GRSP UNECE R14 Workshop on Extended Use
Positions

27.05.2024 | B. Lorenz | BAST

OICA Proposal for R14 Extension

R14 Extension

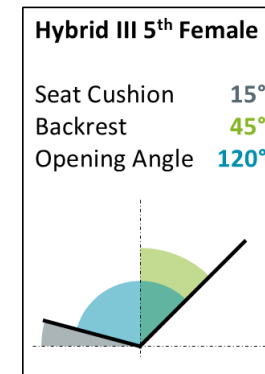
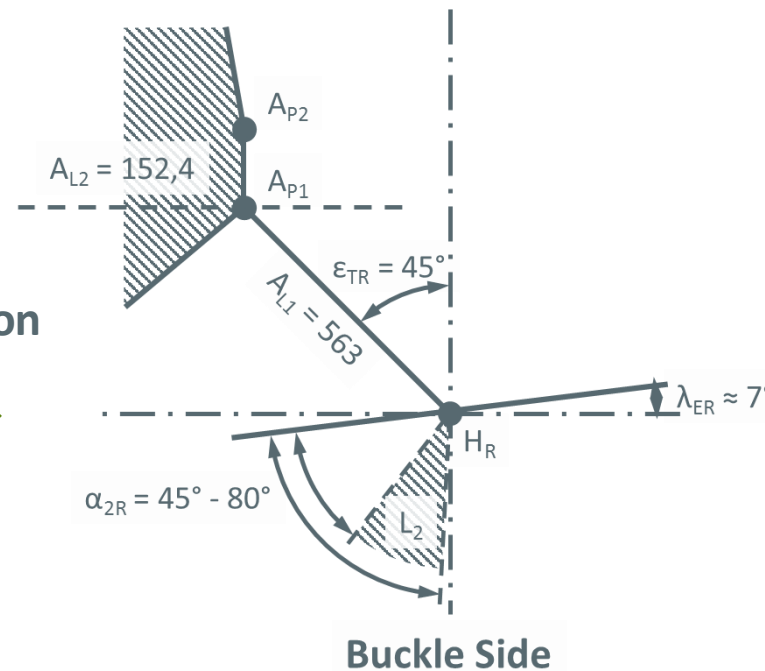
- ▶ Permitted area is redefined for extended use positions (WSR14_8):
 - ▶ Upper anchorage point rotates with the backrest
 - ▶ Lower anchorage points are dependent on the change in the seat cushion and backrest inclination

Workshop: OICA Proposal for R14 Extension

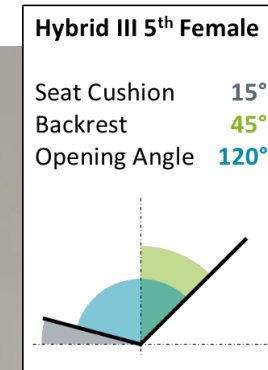
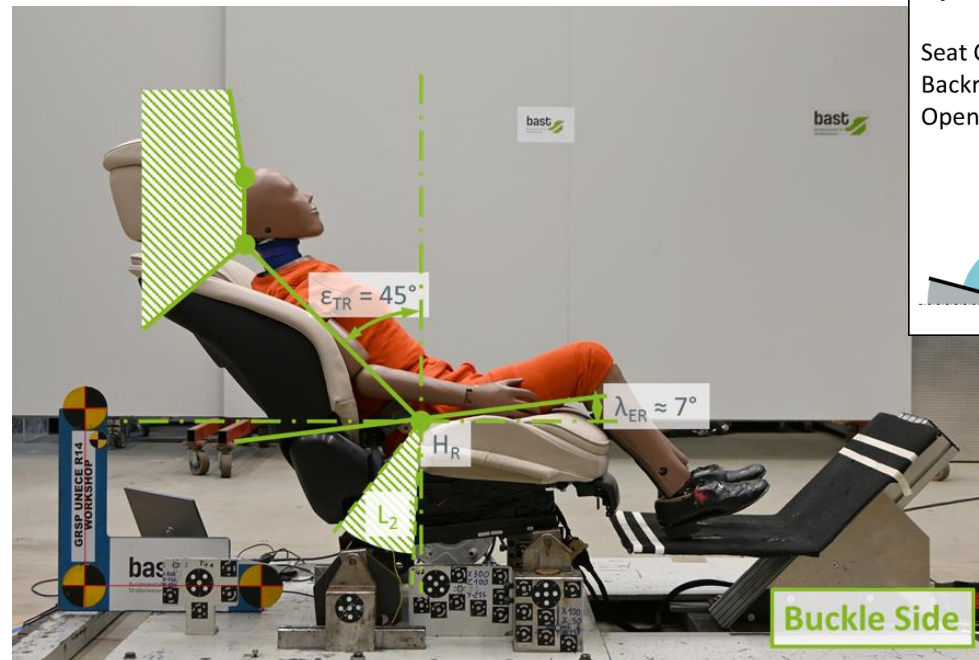
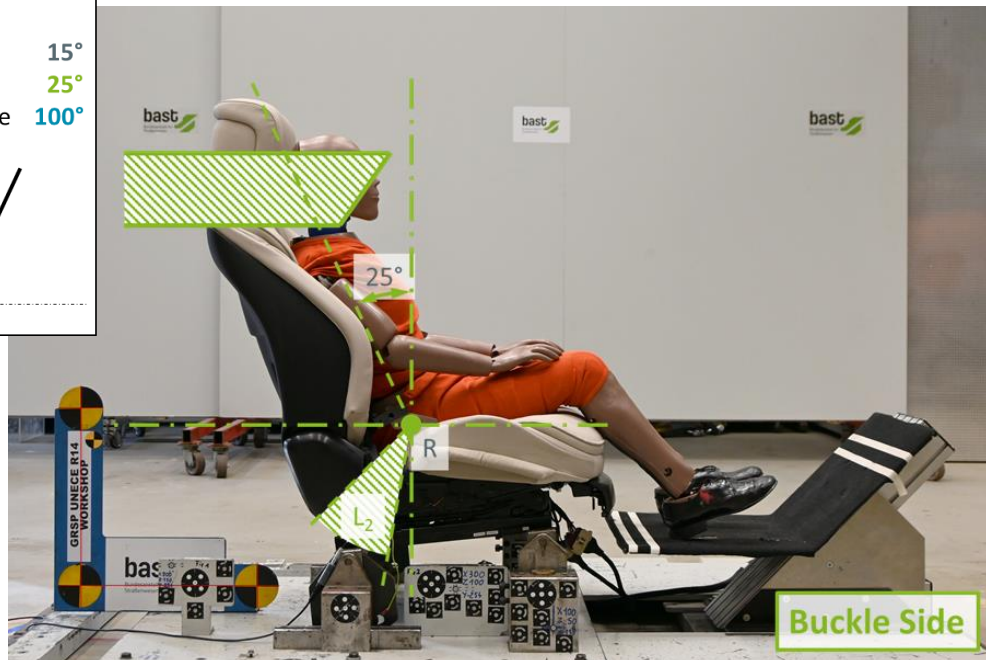
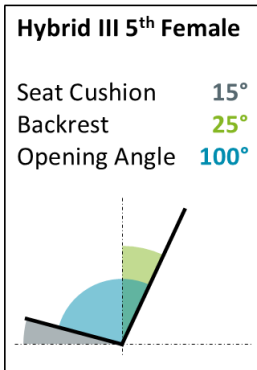
- ▶ Discussion of OICA's proposal (WSR14_8) in a vehicle seat with different configurations and different dummies:
 - ▶ No continuous contact between back and backrest for the Hybrid III family for 120° opening angle
 - ▶ Proposal to extend the R14 was positively received
 - ▶ Proposed area probably too high for an optimal belt routing for small occupants
 - ▶ The proposal allows L1 and L2 to be located in front of the H-point
